Recommendation for Value for SNDR in Table 94-13 and SNR_{tx} in Table 94-17 in reference to comments r01-33, r01-28, r01-54

IEEE P802.3bj Task Force

March 2014

KP4 COM Calculation Comparison with SNR_{tx} options

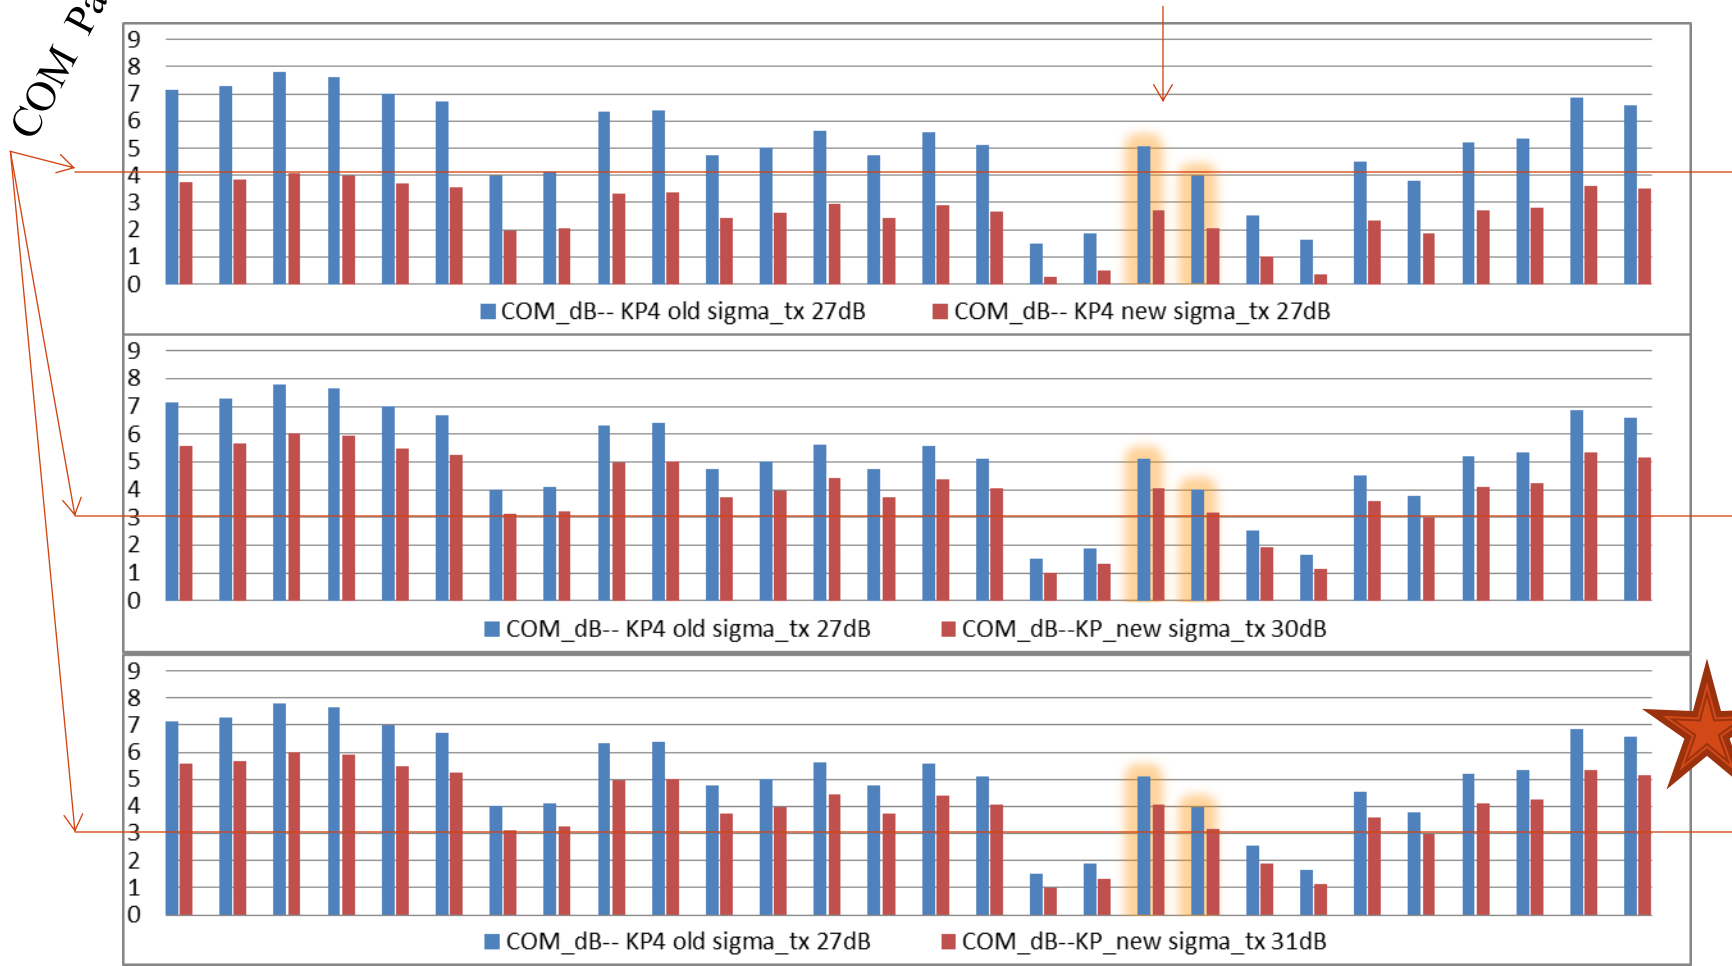
- Keeping SNR_{TX} (SNDR) at 27dB will make it more difficult to design receivers.
- Moving SNR_{TX} (SNDR) to 36.54dB will have little affect on receiver design but makes it more difficult to design transmitters.
- Recommended value is 31 dB which splits the impact between transmitter and receiver
 - For published channels there is no change in pass/fail. (See following Graphs)
